EPA-450/3-80-032b

Benzene Fugitive Emissions— Background Information for Promulgated Standards

Background Information
Final Environmental Impact Statement
Benzene Fugitive Emissions

Figure 2-1. Emission factors for light liquid-service pump seals for benzene, coke oven by-product, cumene, and petroleum refinery units.

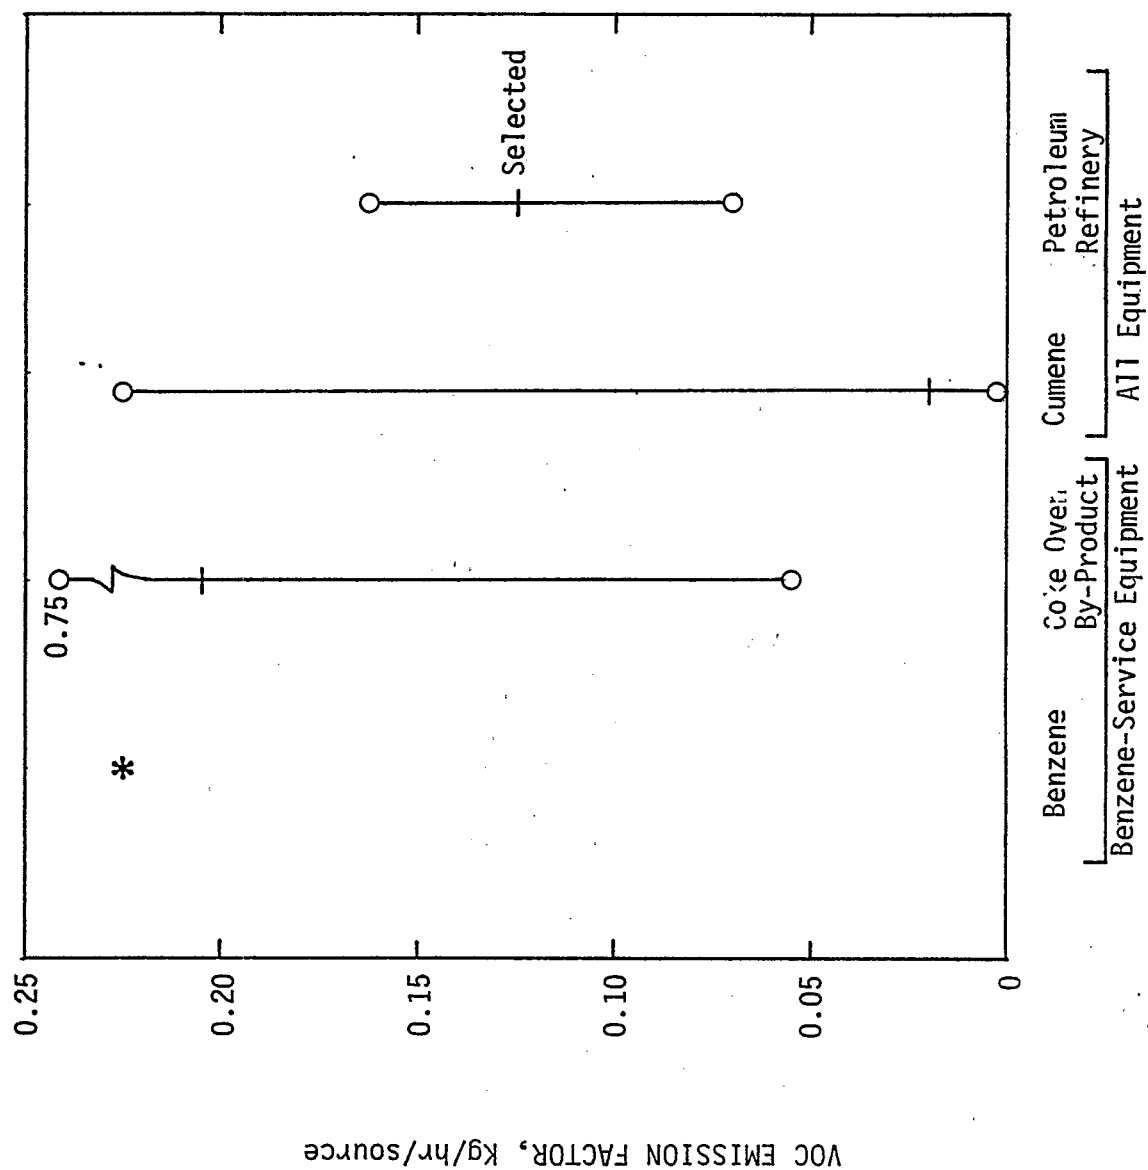
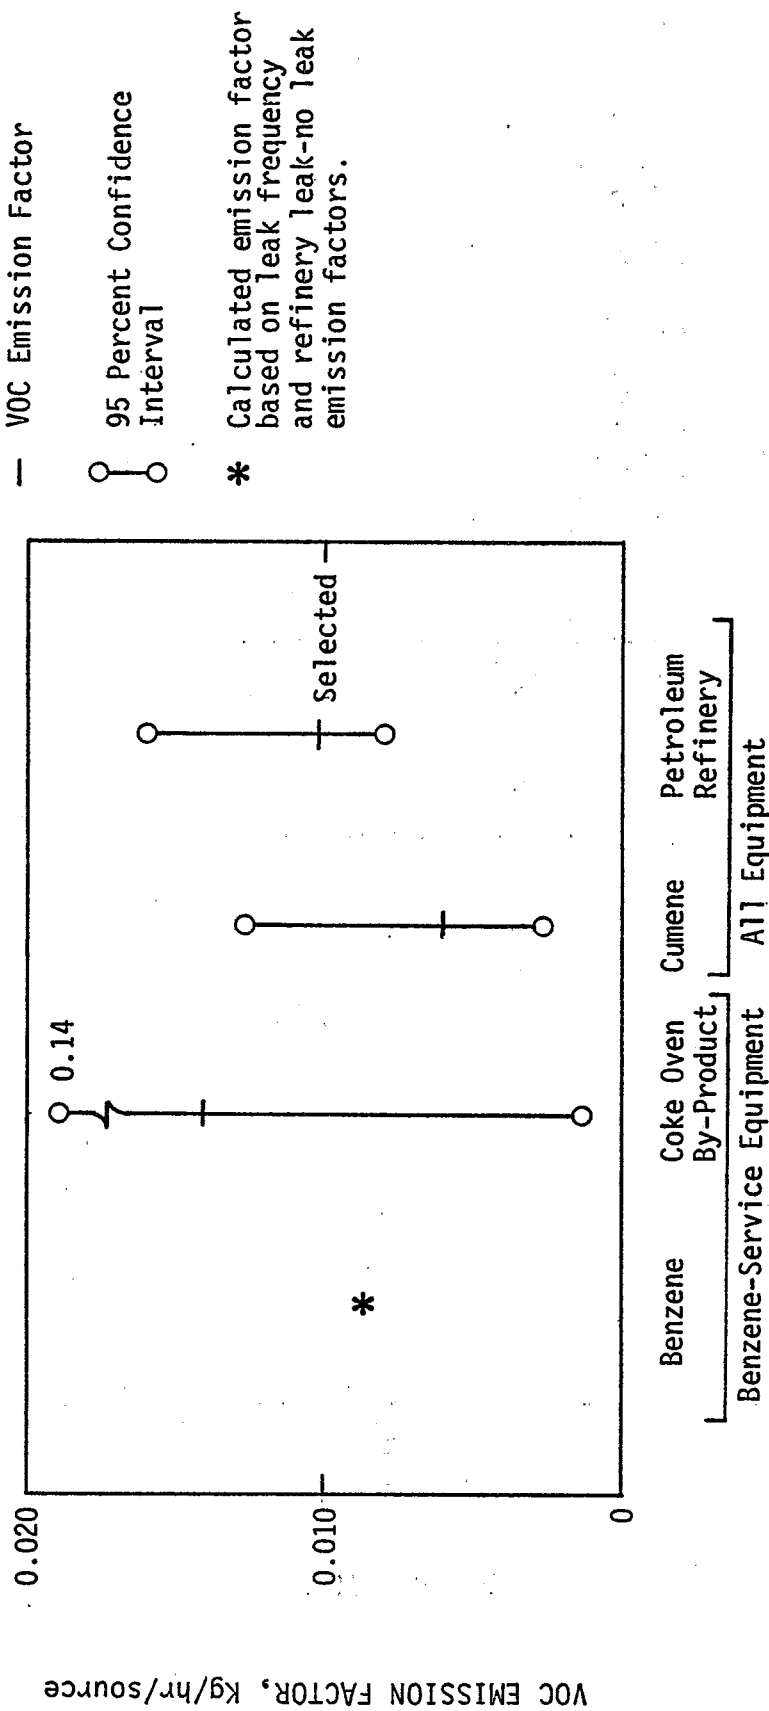
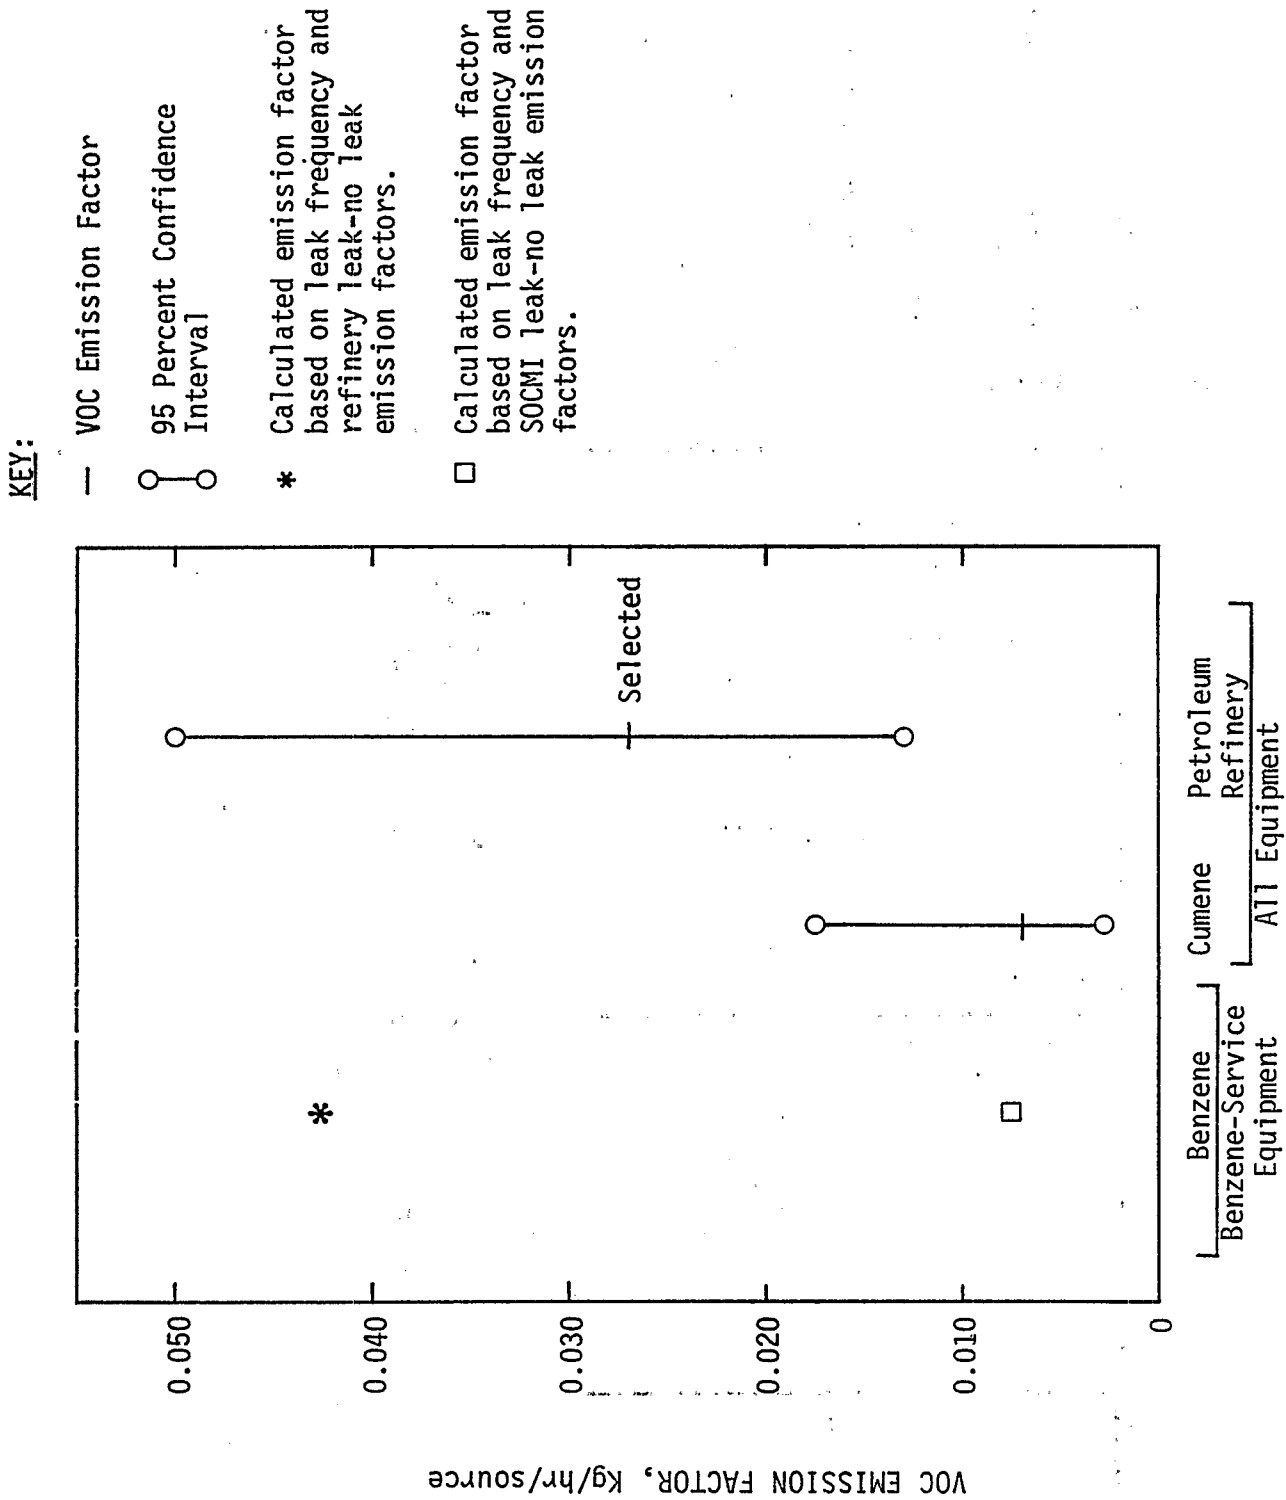
Figures 2-1 through 2-3. Because of the limited amount of data collected in these plants, the confidence intervals for the VOC emission factor estimates are very large. These confidence intervals completely overlap the refinery factor confidence intervals. In addition, the actual estimates are within the confidence intervals of the refinery emission factors for both light liquid pumps and valves. Additional testing was performed at coke oven by-product plants to compare the weight fraction benzene in the process stream to the weight fraction benzene in a leak from that process stream. These data show that the average difference in the benzene fraction was -15 percent; that is, the weight fraction benzene in the leak averaged only 15 percent greater than the weight fraction benzene in the process line. (If the absolute values of the differences between the process stream and leak fraction benzene are used, the average difference is 19 percent). The largest percent differences were found for the sources with the lowest leak rates. These differences are well within the accuracy of the determination of the percent benzene and the emission rate determinations, so they are not significant (IV-B-23).
